MODEL
2015-2016MY
Sedona (YP)

NUMBER
036 (Rev 1, 06/23/2017)

TECHNICAL SERVICE BULLETIN

SUBJECT: COMBINATION TSB / SERVICE ACTION:
A/C DISCHARGE HOSE REPLACEMENT (SA267)

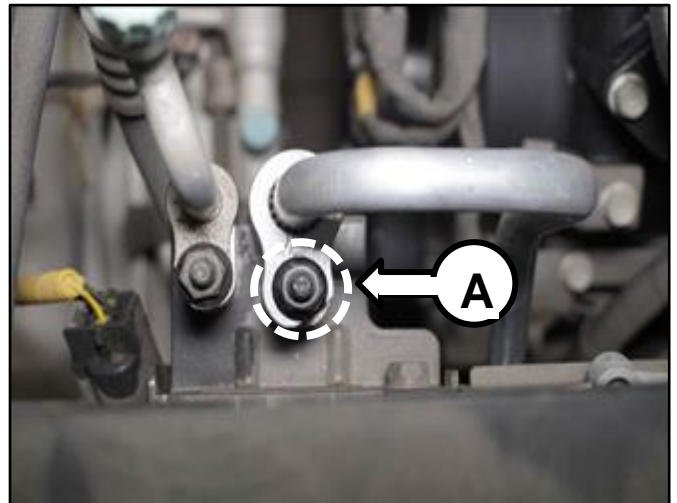
This bulletin provides information about the A/C discharge hose replacement on certain 2015-2016MY Sedona (YP) vehicles produced from March 1, 2015 through March 29, 2016, which may exhibit a refrigerant leak due to poor heat resistance at the swaging spot of the A/C discharge hose. Kia is requesting the completion of this Service Action on all affected vehicles. Before conducting this procedure, verify that the vehicle is included in the list of affected VINs.

A/C Discharge Hose

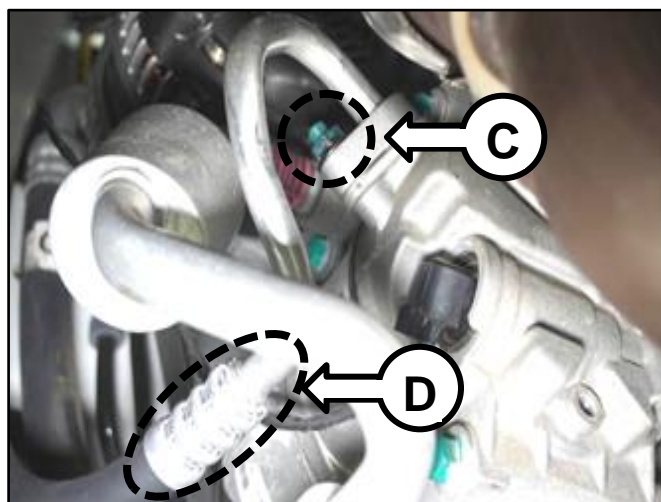
7. After loosening the nut (C) at the compressor discharge connection, remove the A/C discharge hose (D) and discard.

8. Install a new A/C discharge hose on the compressor and tighten/torque the nut.
9. Reinstall all removed components in the reverse order of removal, ensuring both ends of the A/C discharge hose are connected and the nuts are properly tightened/torqued.
10. Charge the system with refrigerant by referring to the "Heating, Ventilation & A/C (HVAC) → Air Conditioning System → Repair Procedure → System Charging procedures" chapter in the applicable Workshop Manual.
11. Confirm proper operation of the A/C system.
12. Reprogram the customer's radio presets, if necessary.
